# WCF2019-0007

A Wireless Communications Facility Permit to replace an existing  
communications tower

June 23, 2019

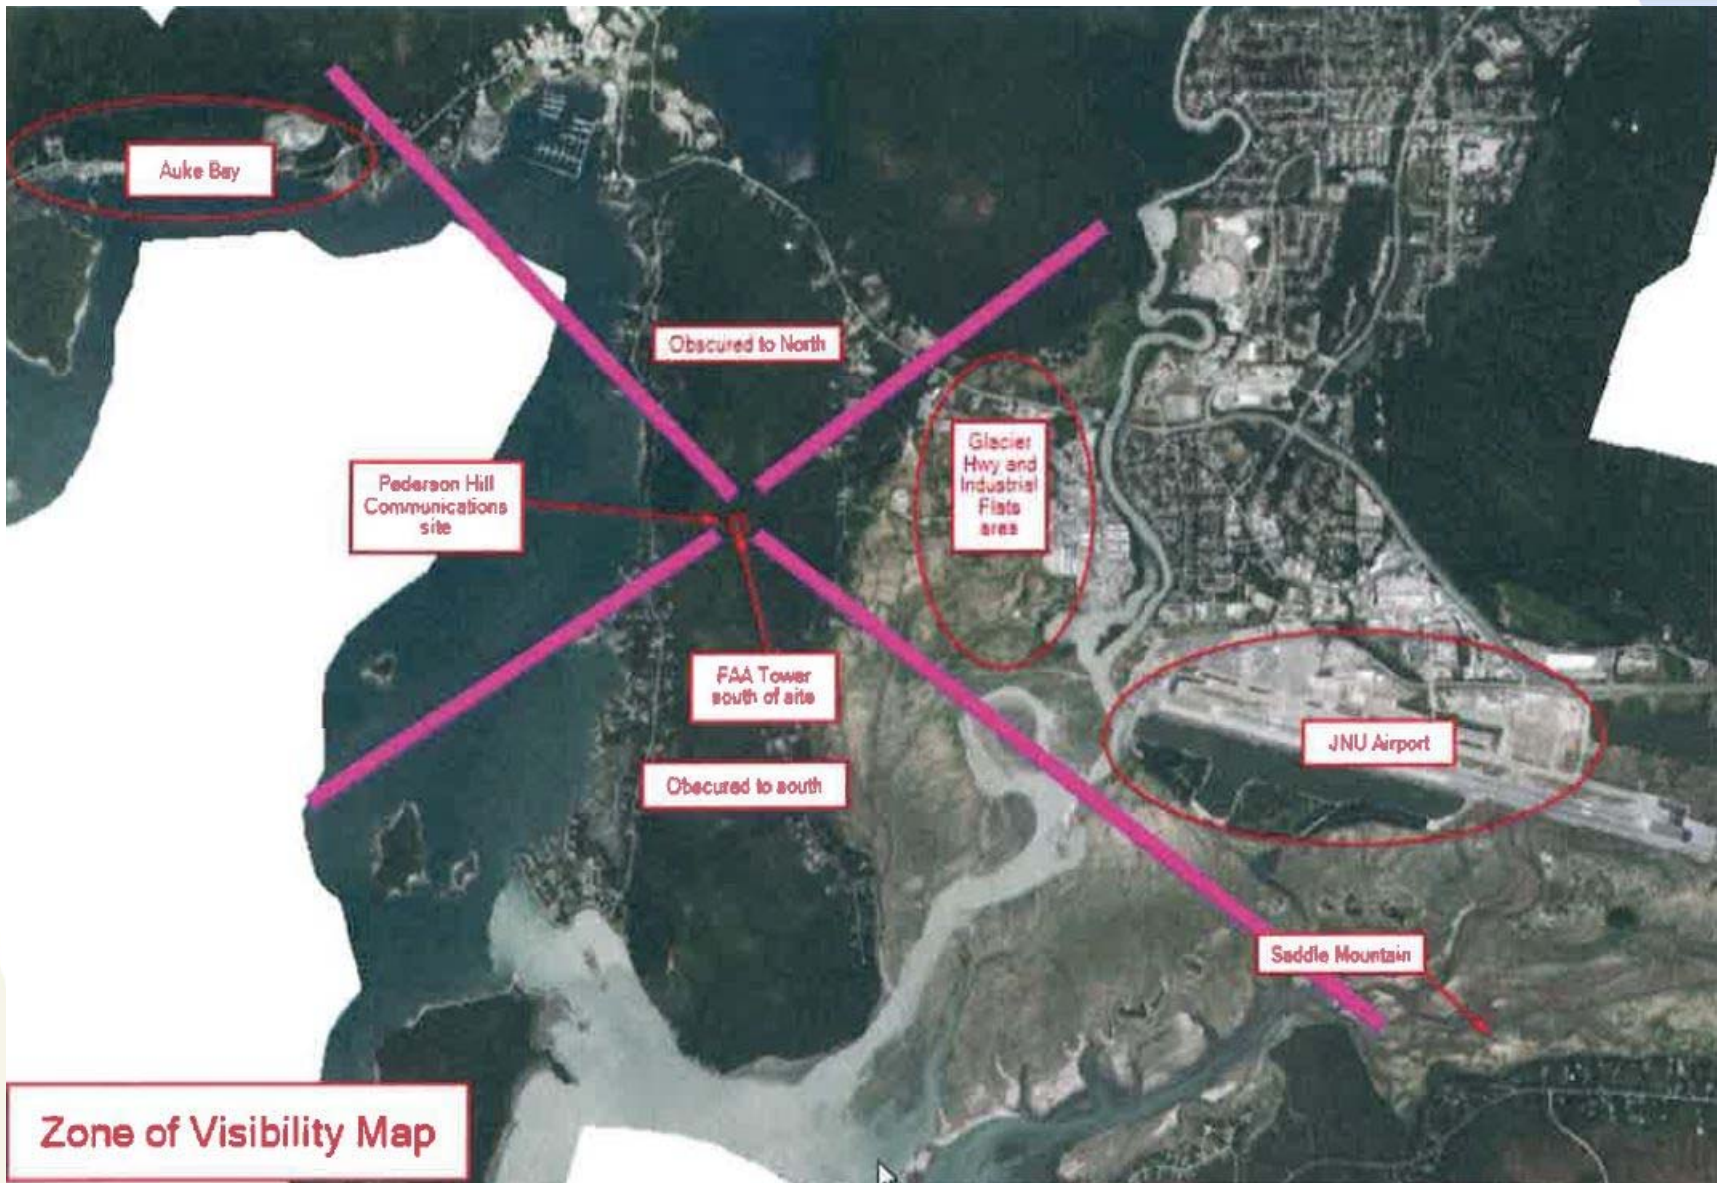
- **Signage:** The application does not indicate plans to install signage consistent with CBJ 49.65.930(c), which states:

*WCFs shall contain a sign no larger than four square feet with text in a sufficient font size to provide adequate notification to persons in the immediate area of the presence of an antenna that has transmission capabilities. The sign shall contain the name(s) of the owner(s) and operator(s) of the facility, an emergency phone number(s), and FCC registration number, if applicable. The sign shall be on the equipment shelter or cabinet and be visible from the access point of the site. The sign shall not be lighted unless authorized by the City and Borough or unless applicable provisions of law require such lighting. No other signage, including advertising, shall be permitted on any WCF, unless required by law.*

**Staff recommends as a condition of approval that signage shall be installed prior to a final certificate of occupancy to meet the requirements of CBJ 49.65.930(c).**
